Subject: SRWRF – CO#7 Justification

MSD
PBU215501L

**South Regional Water Reclamation Facility
PCO #015 - Plant Reuse Water Pump Revised Duty Rating**

Revised Piping

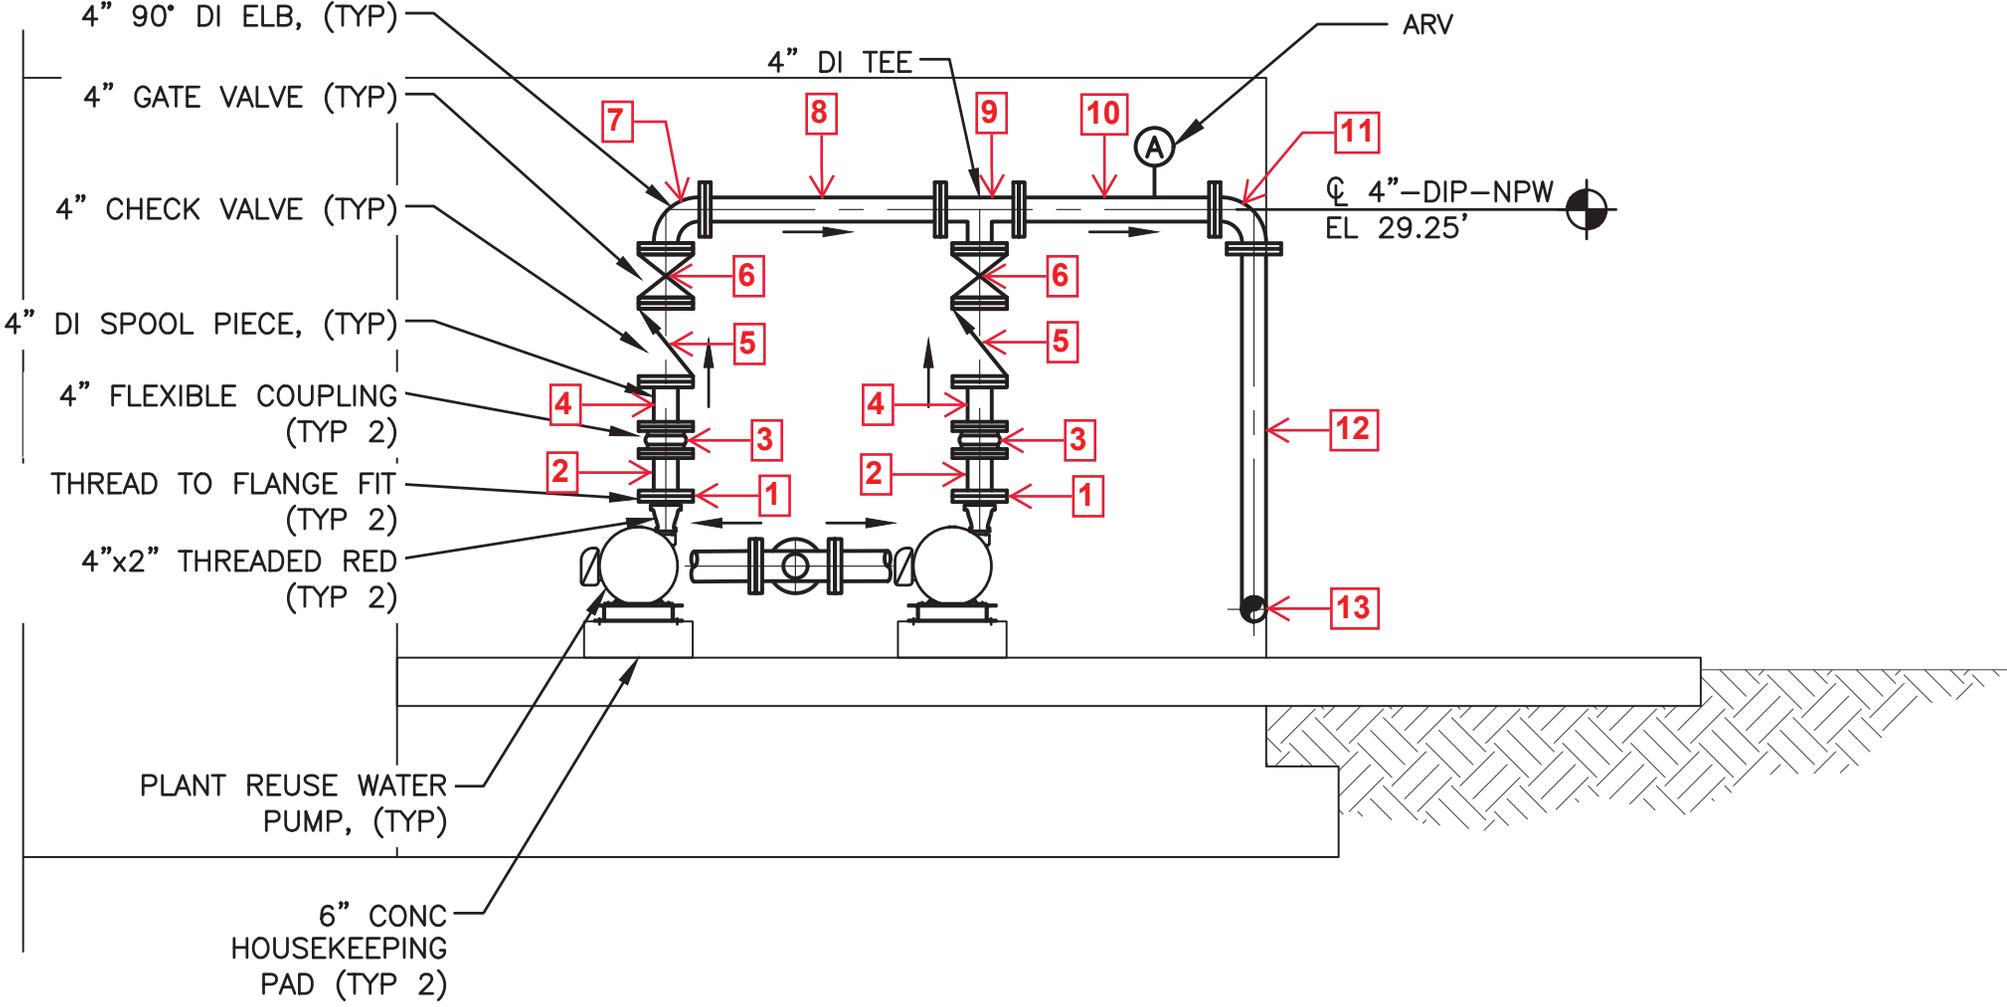
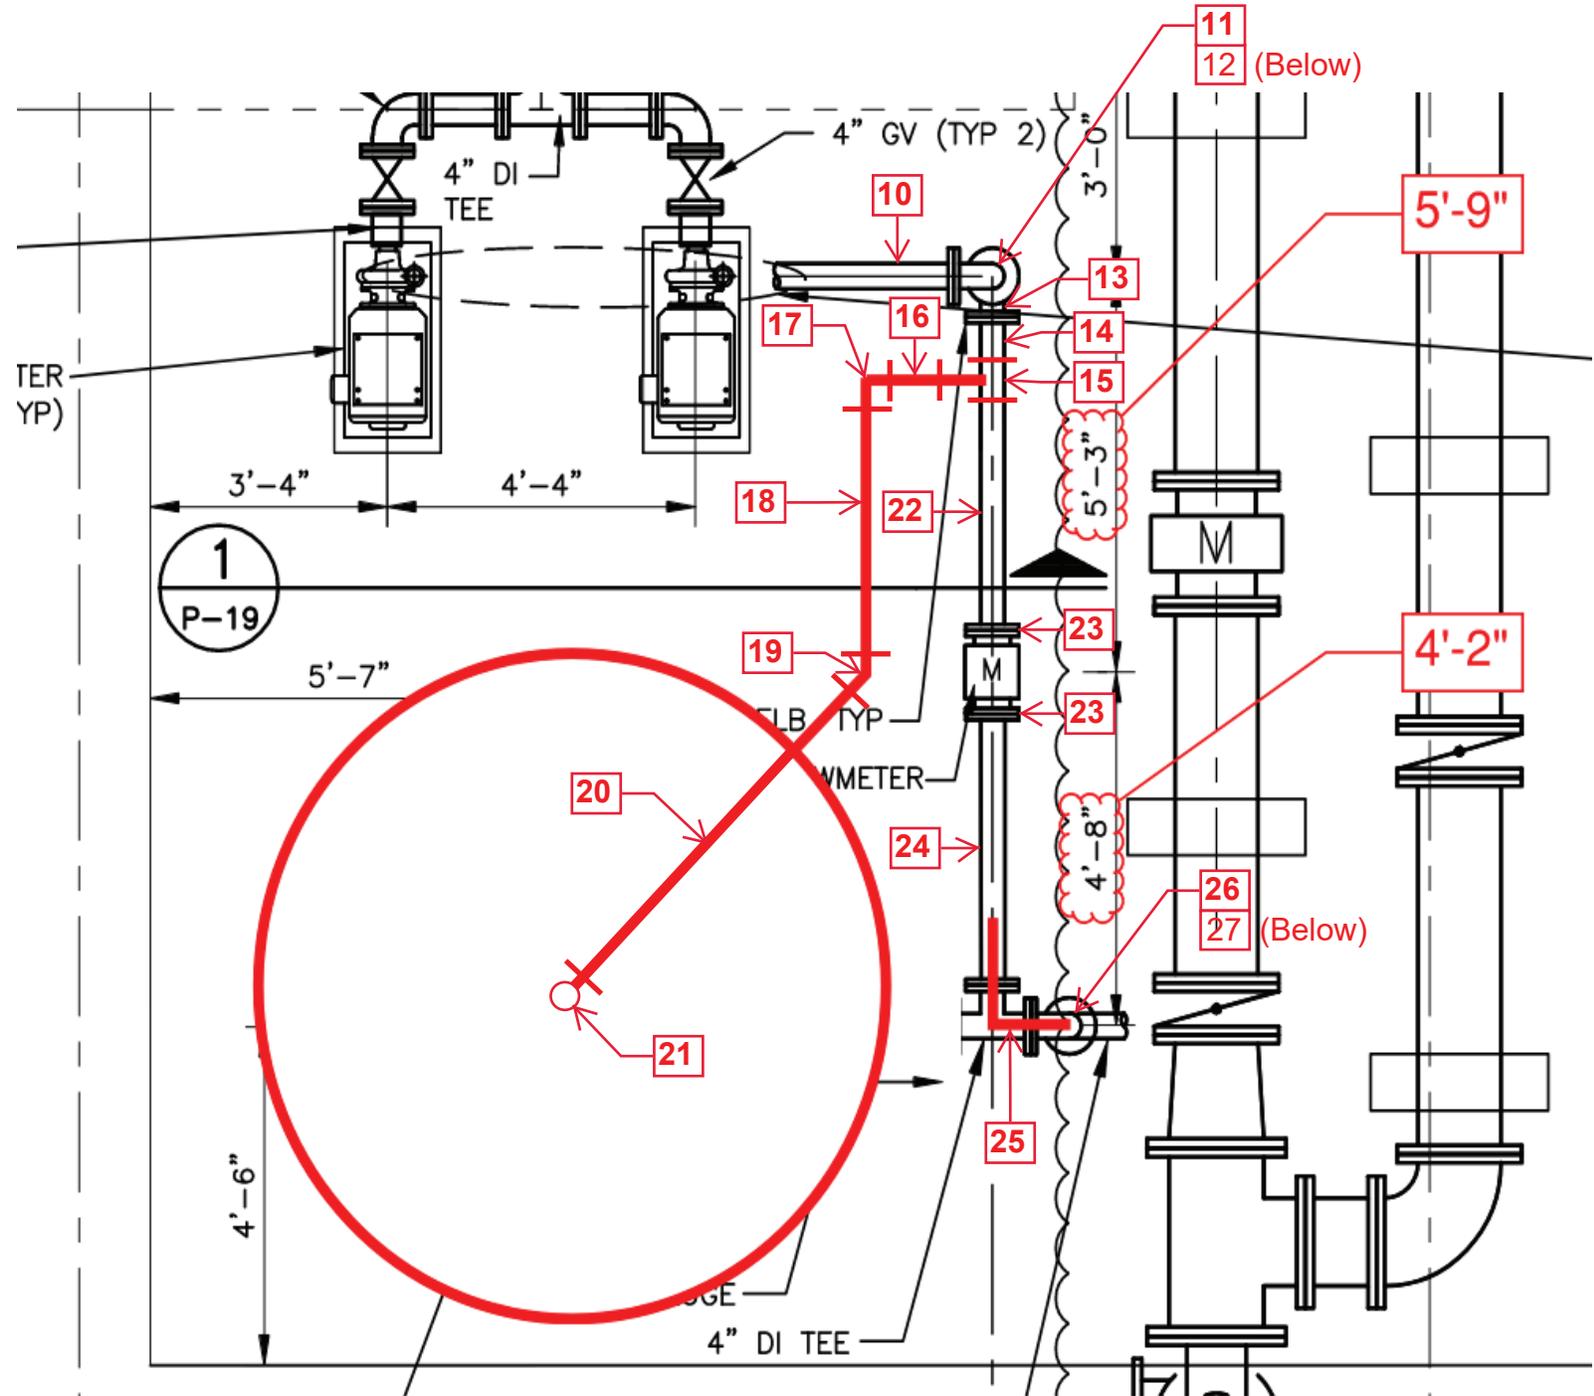
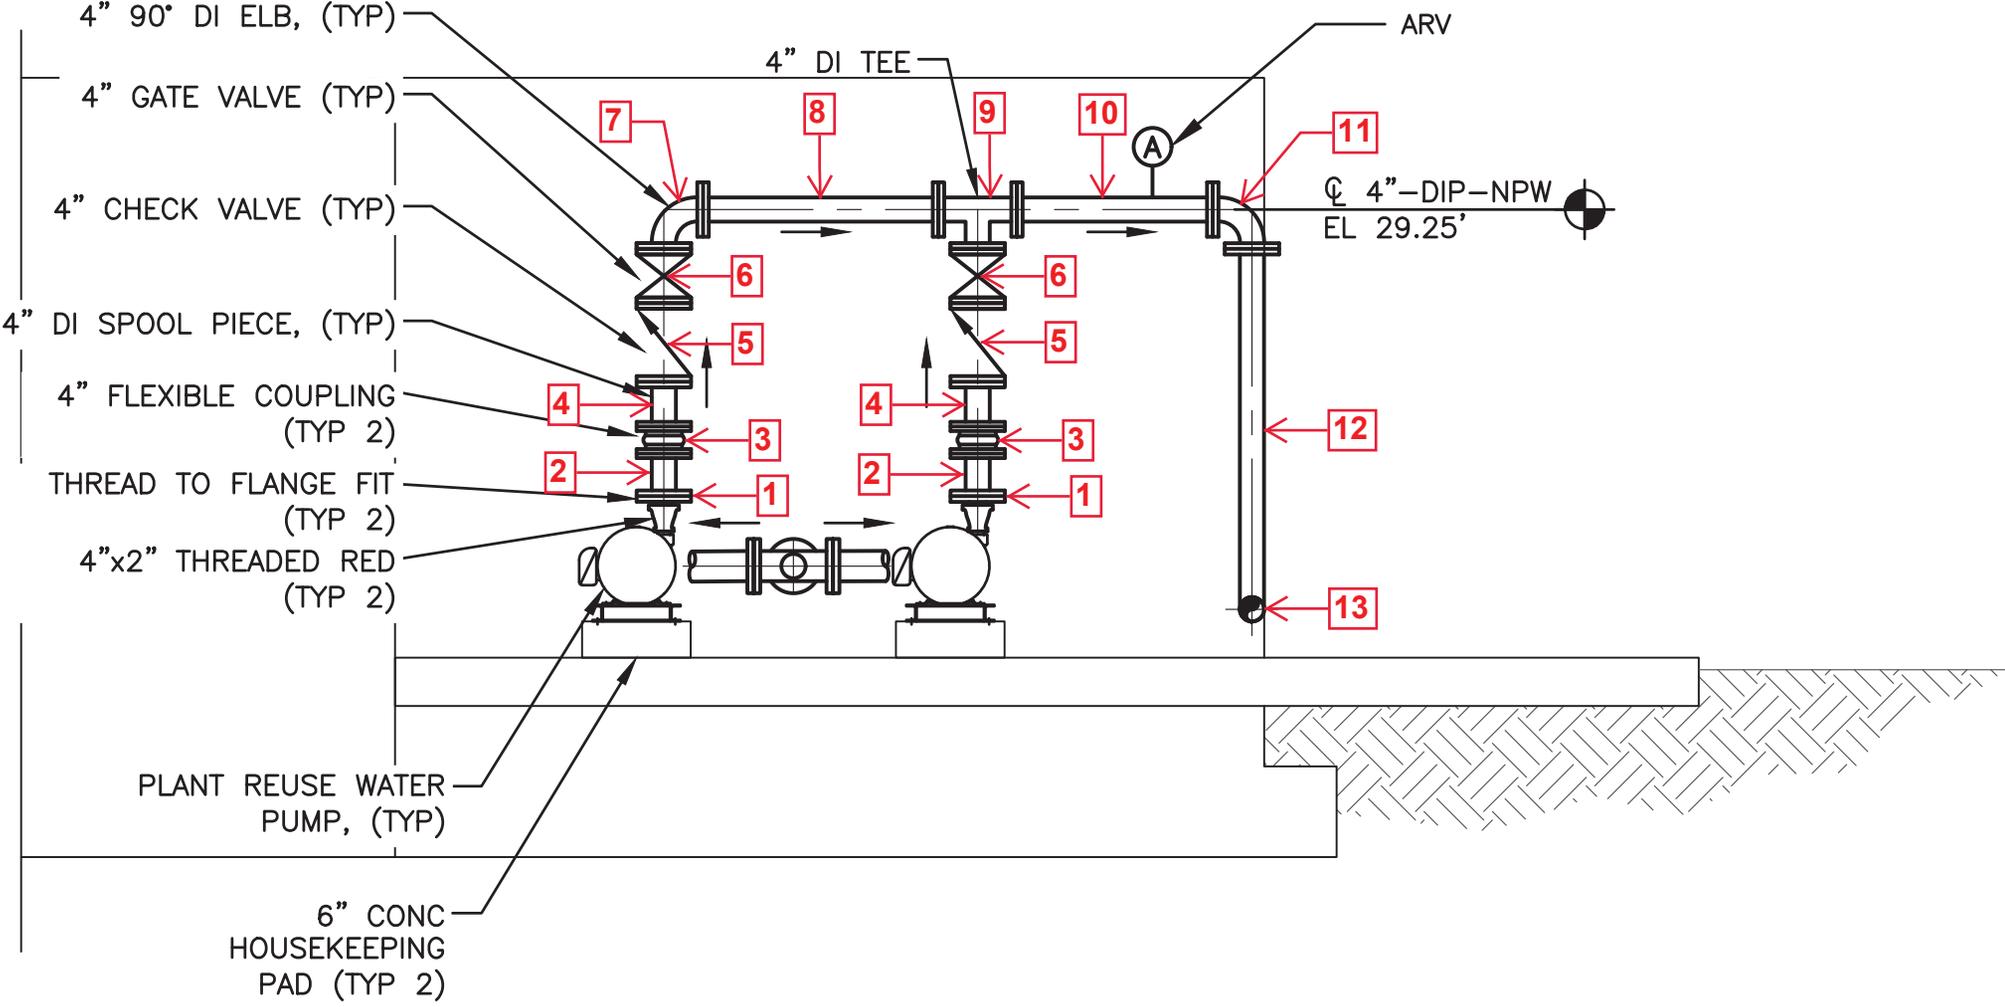
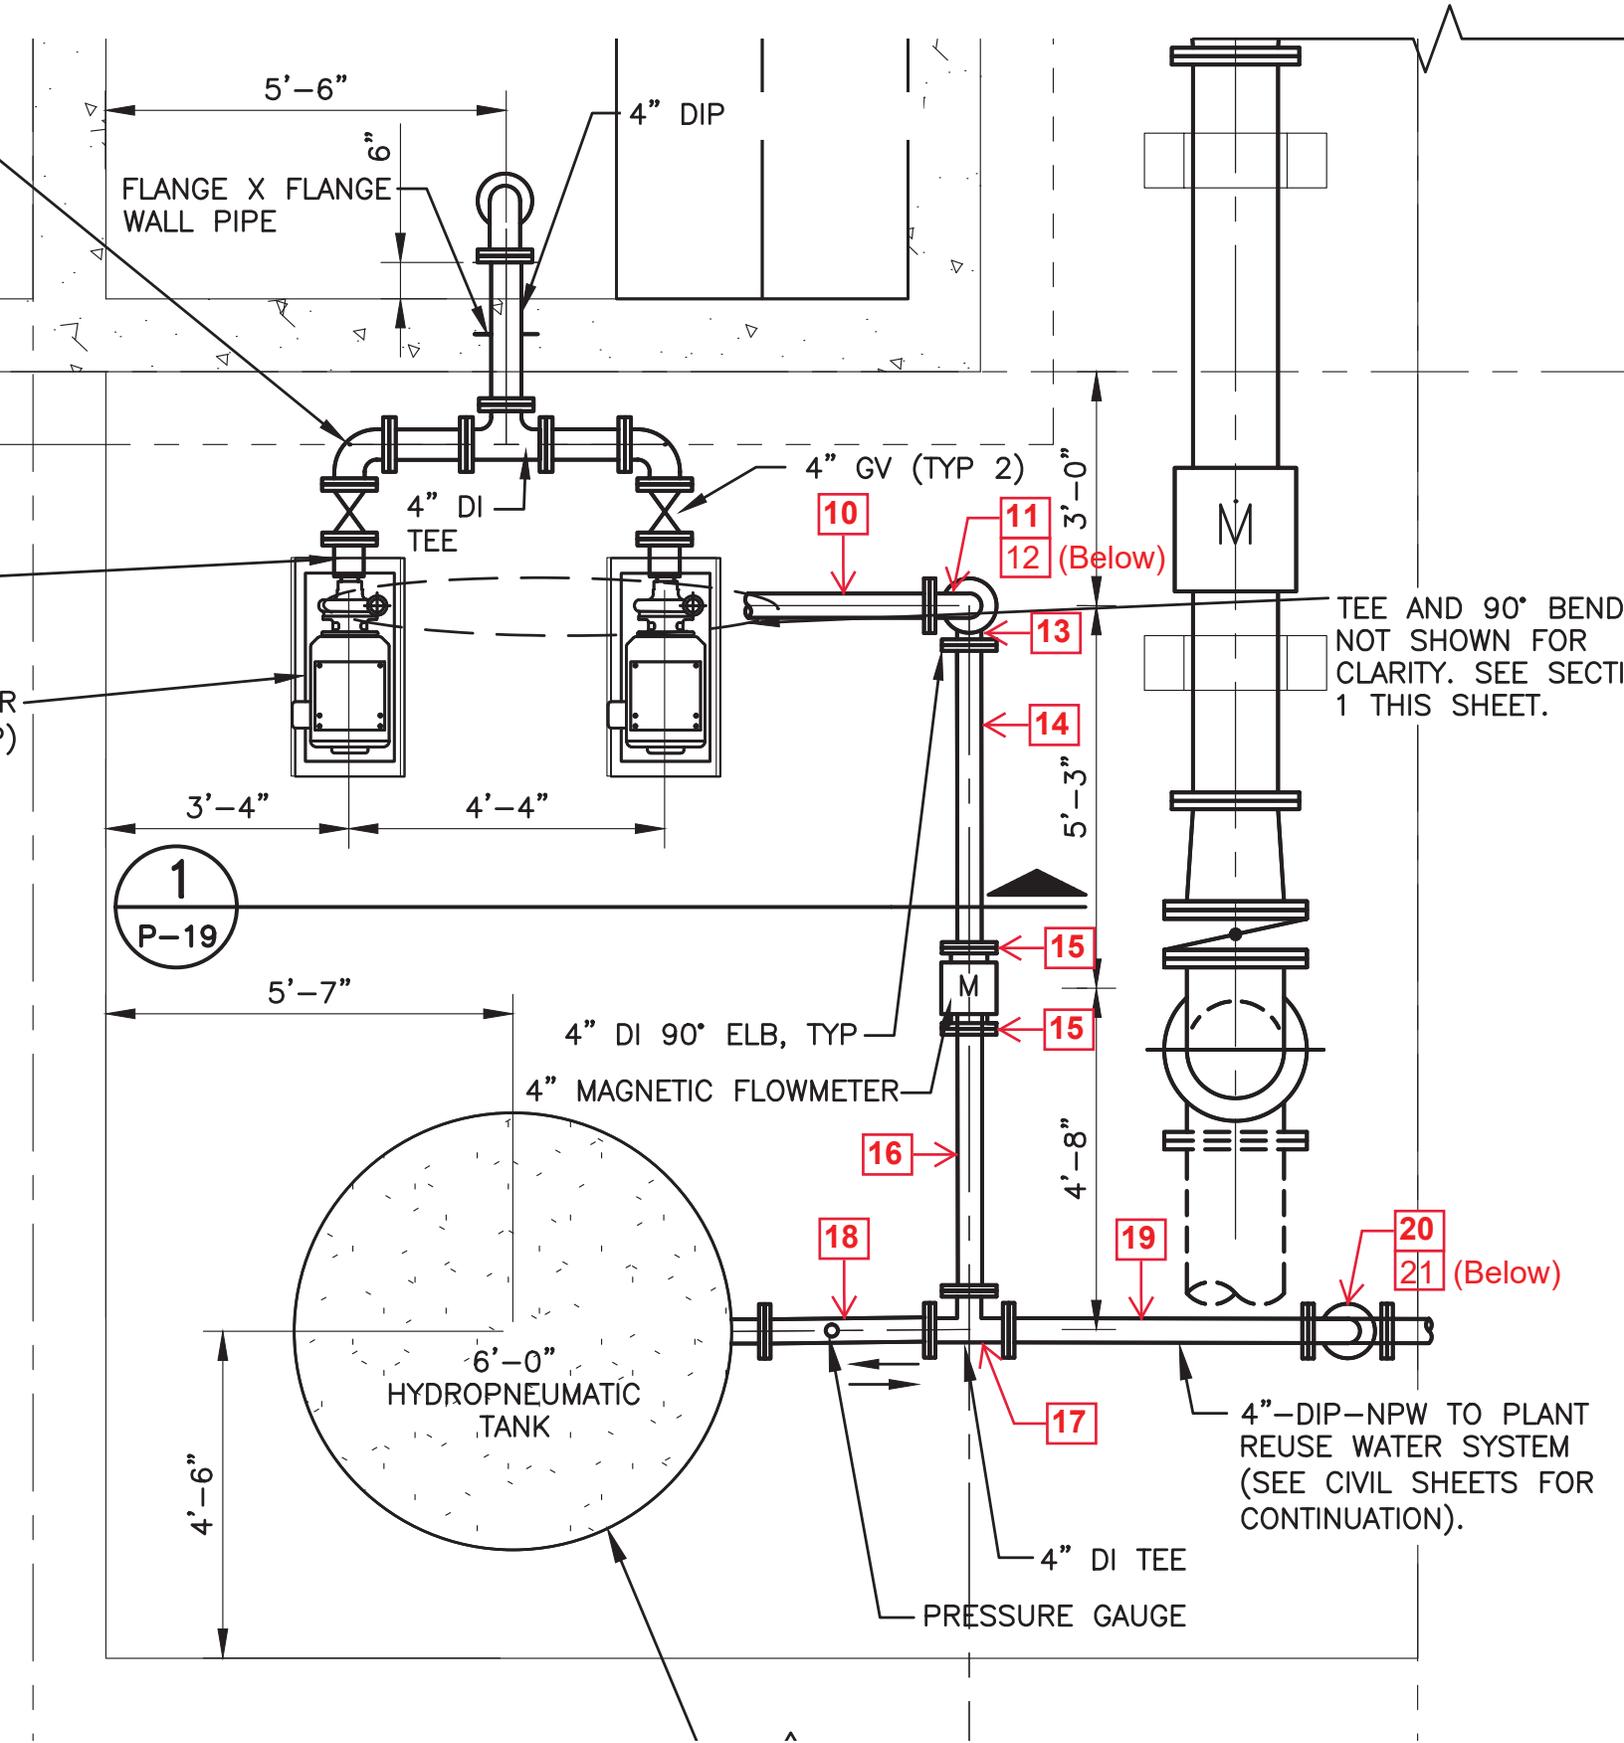
PCO #15 - Additional Items and Items Not Yet Ordered

Item #	Qty Req'd	Unit	Item	Already Ordered	Add
1	2	EACH	4" Companion Flange	0	2
19	1	EACH	4" FLG 45° Bend	0	1
7, 11, 13, 17, 21, 25, 26	7	EACH	4" FLG 90° Bend	4	3
28	35	EACH	4" FLG Accessory Set (02661-2.01B.2.a.ii. & iii. and 15200-2.01B.3.a.ii. & iii.)	29	6
5	2	EACH	4" FLG Check Valve (15200-2.06B.)	2	0
3	2	EACH	4" FLG Flexible Connection (15200-2.01H.)	0	2
23	2	EACH	4" FLG Gasket Only (02661-2.01B.2.a.ii. and 15200-2.01B.3.a.ii.)	2	0
6	2	EACH	4" FLG Gate Valve (15200-2.06F.)	2	0
9, 15	2	EACH	4" FLG Tee	2	0
2, 4, 14	5	EACH	4" x 00'-08" FLG x FLG	0	5
16	1	EACH	4" x 01'-00" FLG x FLG w/ 1/2" Tap	0	1
22	1	EACH	4" x 02'-08" FLG x FLG	0	1
10	1	EACH	4" x 02'-08" FLG x FLG w/ 1" Tap	0	1
8	1	EACH	4" x 03'-03" FLG x FLG	0	1
24	1	EACH	4" x 03'-08" FLG x FLG	0	1
12, 18	2	EACH	4" x 04'-08" FLG x FLG	0	2
27	1	EACH	4" x 06'-00" FLG x PE	0	1
20	1	EACH	4" x 10'-00" FLG x FLG	0	1

PCO #038
Revised Odor Control Duct

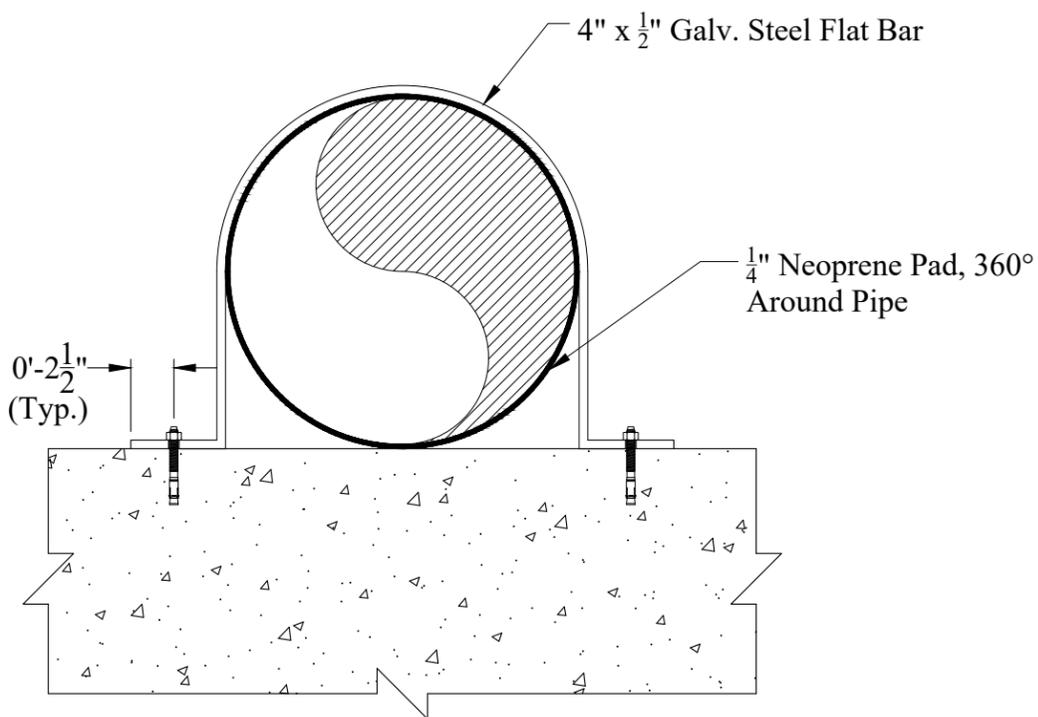
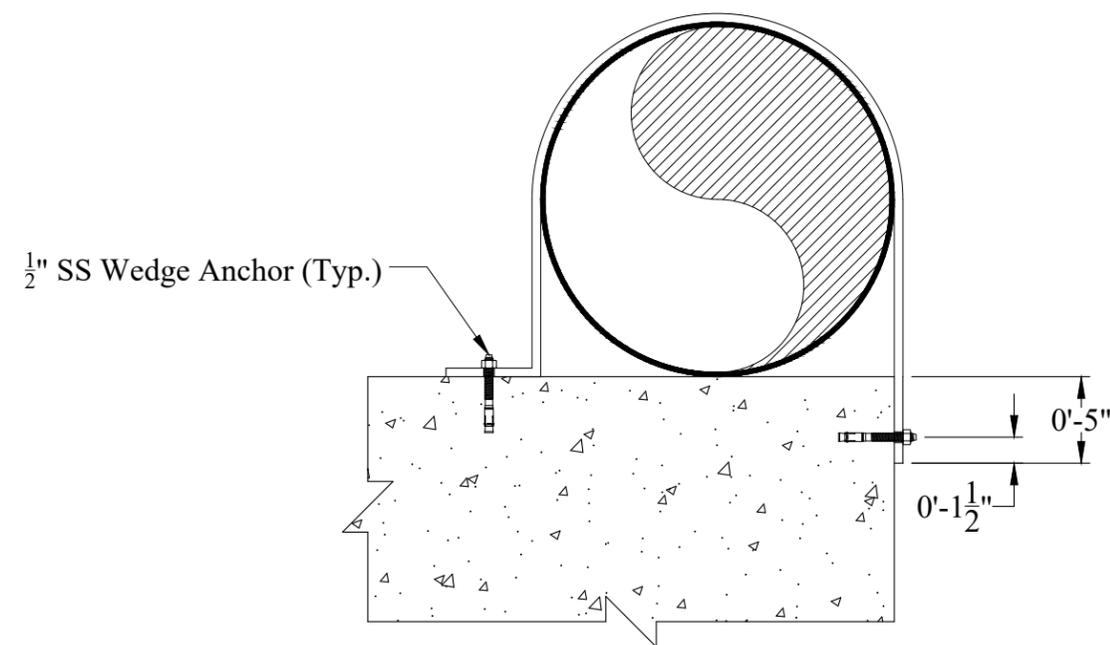
Operating parameters for each piece of equipment were reviewed. As a result of the review, odor control duct sizes and routing were revised. The contractor’s PCO was for \$170,576.82 and 155 days which included \$37,788.00 for additional bonds, primarily due to the extra time.
